A Discussion of

"Analysis of Structural Response of WTC 7 to Fire and Sequential Failures Leading to Collapse"

Journal of Structural Engineering, January 2012, Vol. 138, No. 1

Ronald H. Brookman, M.S., S.E.¹

Figure 1: Plan View at Floor 13, Column 79 Seated-Beam Connection

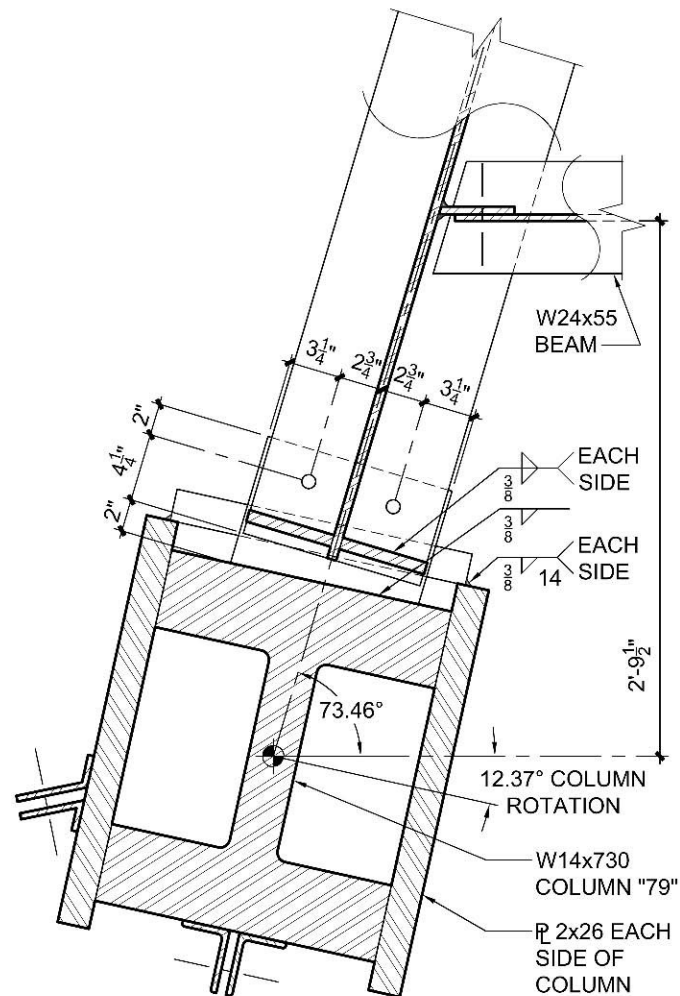
How did the NIST WTC Investigation Team arrive at a 5.5-inch (140 mm) threshold for axial "walk-off" of the girder at column 79? The bearing length at column 79 was 6.25 inches (159 mm) along the girder's axis as shown on fabrication drawings 1091 and 9114 (Frankel Steel 1985b), and the girder was restrained between columns 44 and 79.

Could "walk-off" occur with a 6.25-inch (159 mm) lateral displacement? Figure 1 illustrates a plan view of the seated-beam connection with dimensions and geometry shown to scale. Figure 2 shows the same connection in a section view through the girder. The one-inch (25 mm) thick bearing plate was 12 inches (305 mm) long and 8.25 inches (210 mm) wide at its widest point. Stiffener plates were welded on each side of the girder web.

Figure 2: Section View at Floor 13, Column 79 Seated-Beam Connection
 (Data from Frankel Steel Limited, 1985b)

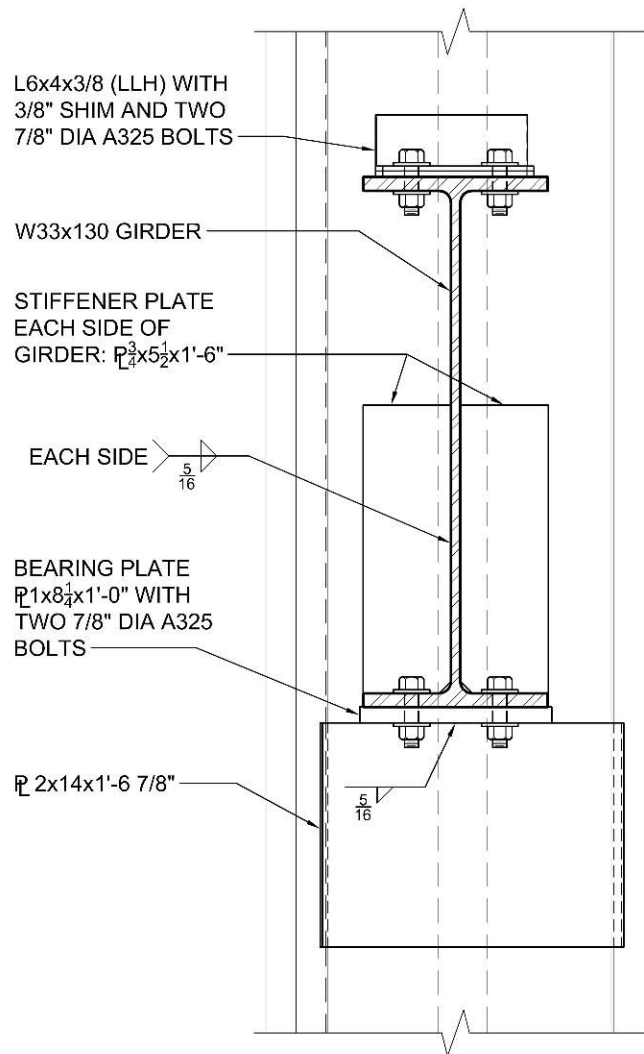
The analytical model for the seated-beam connection at column 79 (McAllister et al. 2008) does not account for the presence of stiffener plates as shown in fabrication drawing 9114 (Frankel Steel 1985b). This drawing illustrates $\frac{3}{4}$ -inch (19 mm) thick partial-height web stiffeners welded to the girder web and bottom flange directly over the bearing surface. Fillet welds connecting the

stiffeners were adequate to transfer the vertical shear from the girder web to the stiffeners, and a lateral displacement of 6.25 inches (159 mm) would not necessarily cause a loss of vertical support. The authors' assumption that the flexural stiffness of the girder bottom flange was "*insufficient to transfer the gravity loads*" is untenable. Why were these stiffeners omitted from the ANSYS connection model when they obviously affect the bending characteristics of the girder bottom flange?
